PLANNING DIVISION STAFF REPORT

Project Address: 202-212 S. Baldwin Street (6th Aldermanic District, Alder Rummel)
Application Type: Demolition Permit
Legistar File ID # [62095](#)
Prepared By: Chris Wells, Planning Division
Report Includes Comments from other City Agencies, as noted
Reviewed By: Kevin Firchow, AICP, Principal Planner

Requested Action: The applicant requests approval of a demolition permit to raze three existing commercial buildings in order to expand McPike Park at 202-212 S. Baldwin Street.

Image 1 – Proposed Demolitions

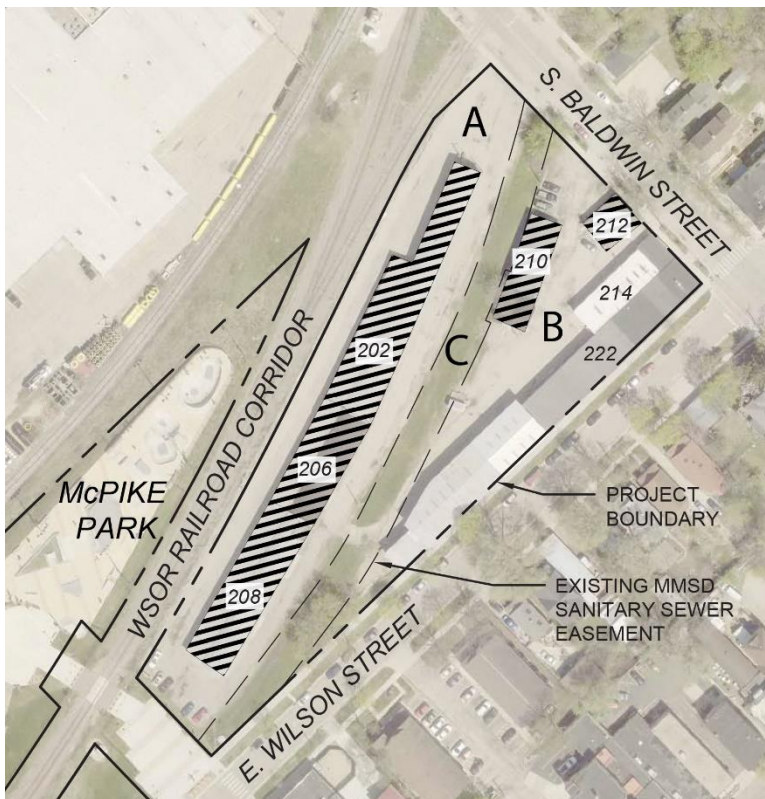
The more easterly parcel, generally addressed as 214 S. Baldwin Street (labeled as “B” in the image below), has three commercial structures - two of which are proposed to be razed. The first, addressed at 210 S. Baldwin Street, is a roughly 2,500-square-foot office/storage building constructed of concrete masonry block and timber. The year of construction is estimated to be in the mid 1930’s. Submitted photos of all structures proposed for demolition are available for viewing [here](#). For the structure at 210 S. Baldwin Street, the photos show a dated building in below average condition with signs of interior weather damage. In submitted materials the applicant notes that *“the building has limited potential for adaptive reuse for park purposes given its configuration and condition.”*

The other building proposed for demolition is a roughly 1,000-square-foot, single-story, office building addressed at 212 S. Baldwin Street. It is also constructed of a combination of concrete masonry block and timber. The year of construction is estimated to be roughly 1908. While submitted photos show a dated building in below average condition, in submitted materials the applicant notes that *“the building has limited potential for adaptive reuse for park purposes given its configuration and condition.”*

The more westerly parcel, generally addressed as 202 S. Baldwin Street (labeled as “A” in the image above), has a single building - an 18,700-square-foot, mini storage building which is addressed as 202-208 S. Baldwin Street and is proposed for demolition. According to submitted materials, it is a pre-manufactured steel and timber building in the Trachte style. The year of original construction is believed to be in the mid 1950’s. It is uninsulated and has no sanitary sewer service. The applicant has indicated that an adaptive reuse of the structure is limited due to its location at a low point on the site. The threat of damage due to flooding is difficult to improve given that the site does not drain well due the fact that the existing storm sewer pipes, located beneath the two adjacent streets, both lie at a higher elevation than that of the site. That said, the applicant has noted that they are open to working with private parties interested in relocating all or portions of the building to another, non-City-owned, site.
